DANIEL L. CLAASSEN 1ST ADDITION AN ADDITION TO WICHITA, SEDGWICK COUNTY, KANSAS

RE: S/D 98-100 -- One-Step Final Plat of DANIEL L. CLAASSEN ADDITION

RE: S/D 98-100 -- One-Step Final Plat of DANIEL L. CLAASSEN ADDITON

CASE NUMBER: S/D 98-100 - DANIEL L. CLAASSEN ADDITION

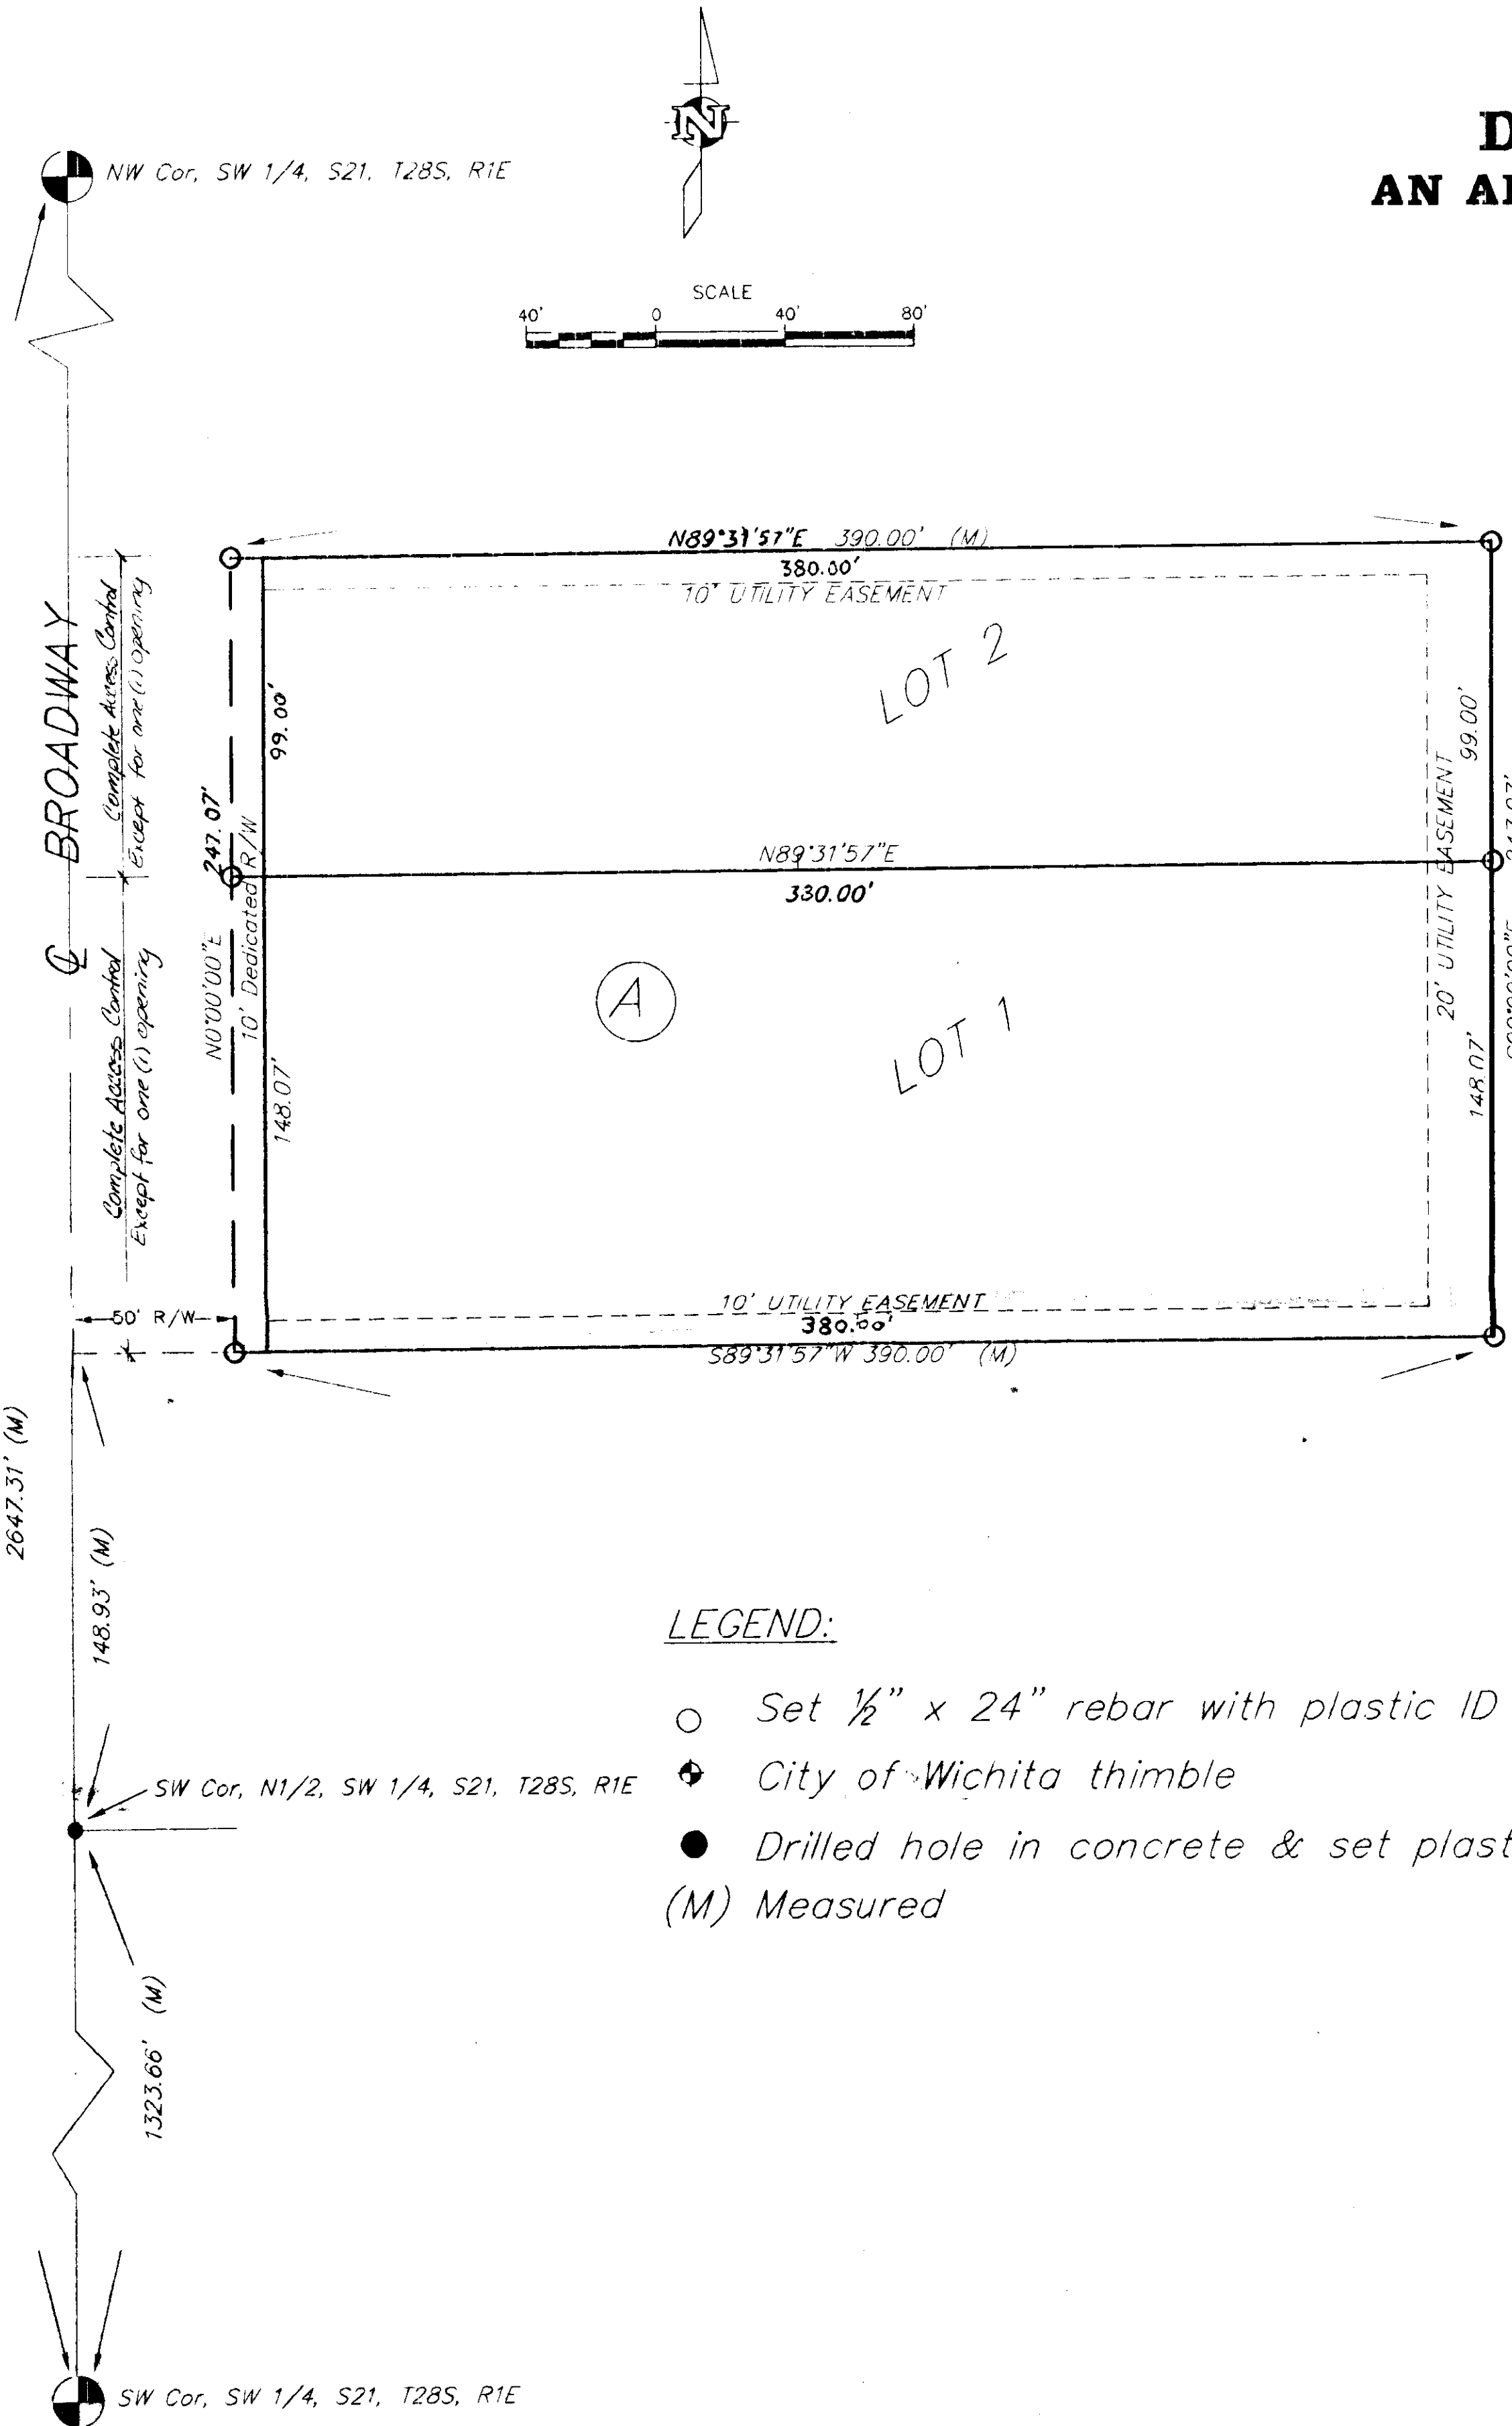
- B. **City Engineering** needs to verify if any guarantees for municipal services or any easements are required. *A guarantee needs to be submitted for a sanitary sewer extension to Lot 1. The Applicant shall contact the adjoining landowner to the south regarding participation in the sewer petition. The utility easement along the rear lot lines needs to be increased to 20 feet to accommodate sanitary sewer. Additional right-of-way needs to be dedicated to line up with the adjoining north and south plats.*

- F. **Traffic Engineering** needs to comment on the number of allowable access openings along Broadway. The dedication of access controls shall be included on the final plat tracing and referenced in the plat's text. The Applicant shall guarantee the closure of any driveway openings being located in areas of complete access control or that exceed the number of allowed openings. **The final tracing shall denote one opening per lot.**

- G. The spelling of "Claassen" needs to be corrected on the final plat tracing.
- H. The MAPC Chairman needs to be revised to "William M. Johnson".
- I. **Traffic Engineering** needs to comment on the need for improvements to Broadway.

- J. The Applicant is reminded that a platting binder is required with the final plat tracing.
- K. The lot depth to width ratio exceeds 3 to 1 for Lot 2, and a modification from the Subdivision regulations will be needed for approval of this plat.

- S. The representatives from the utility companies should be prepared to comment on the need for any additional utility easements to be platted on this property. *The Applicant intends to relocate the utility easement between the two lots to the north and south lines of the plat.*
